# PIC12F683

## PIC12F683 Rev. A Silicon/Data Sheet Errata

The PIC12F683 parts you have received conform functionally to the Device Data Sheet (DS41211B), except for the anomalies described below.

### 8-Lead Plastic Dual Flat No Lead Package (MF) 6x5 mm Body (DFN-S) – Saw Singulated

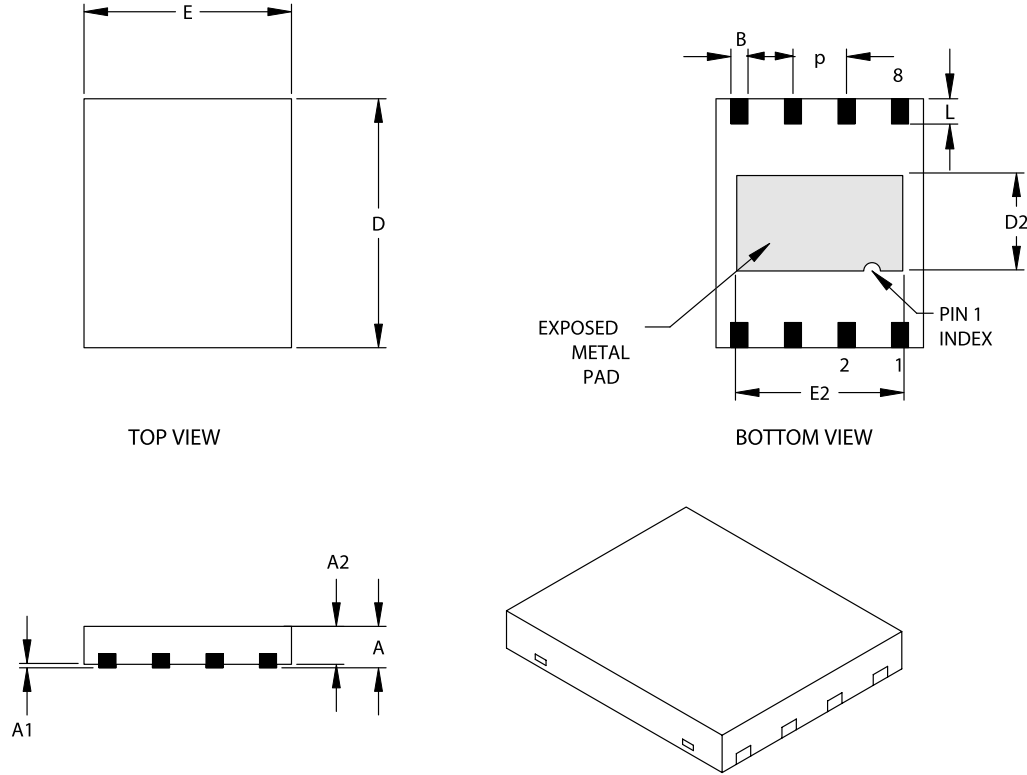
Section 16.2, change “Packaging Details” from the current 8-pin MF packaging (which is no longer used) to the **saw singulated** packaging version, as shown below:
